Item Name: Crosstube Turning Detail

DART AEROSPACE LTD	Work Order:	85872
Description: Crosstube Assembly (205/212 High Aft)	Part Number:	D212-664-241
Inspection Dwg: D212-664-241 Rev: D		Page 1 of 2

DRAWING NO. D212-664-241	TITLE CROSSTUBE ASSY (205/212 HI AFT)	REV. D	DART AEROSPACE LTD ENGINEERING ORDER		D.E.O. NO. D212-664-241-D-1	SHEET NO. SHEET 1 OF 2	SCALE NTS
DRAWN	CHECKED	MFG. APPR.	APPROVED	DE APPR.			
DATE 11.04.07	DATE 11.04.11	DATE 11.04.12	DATE 11/04/12	DATE 11.04.12

DRAWING NO. D212-664-241	TITLE CROSSTUBE ASS'Y (205/212 HI AFT)	REV. D	DART AEROSPACE LTD ENGINEERING ORDER	D.E.O. NO. D212-664-241-D-2	SHEET NO. SHEET 1 OF 1	SCALE NTS
DRAWN <i>q</i>	CHECKED <i>ASS</i>	MFG. APPR. <i>SS</i>	APPROVED <i>MP</i>	DE APPR. <i>MP</i>		
DATE 11.07.15	DATE 11.07.20	DATE 11.07.21	DATE 11/07/21	DATE 11.07.21

**D212-664-241-241B
ASSEMBLY DETAIL**

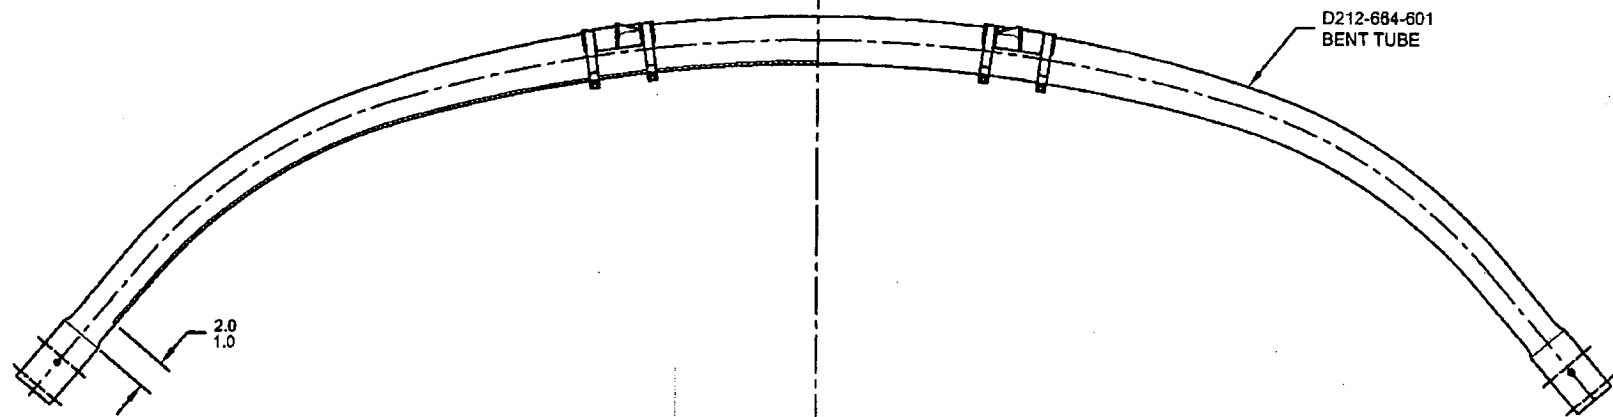
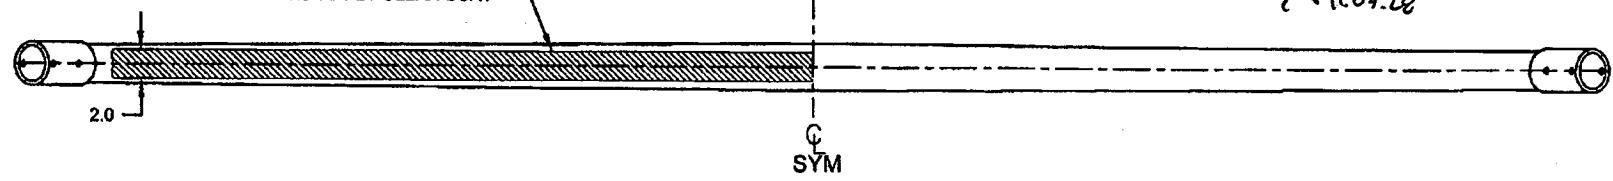
PURPOSE:

ADD AN INSPECTION WINDOW TO UNDERSIDE OF CROSSTUBE.

IS:

WAS:

MASK AREA PRIOR TO PAINTING,
REMOVE MASKING AFTER PAINT
AND APPLY CLEAR COAT
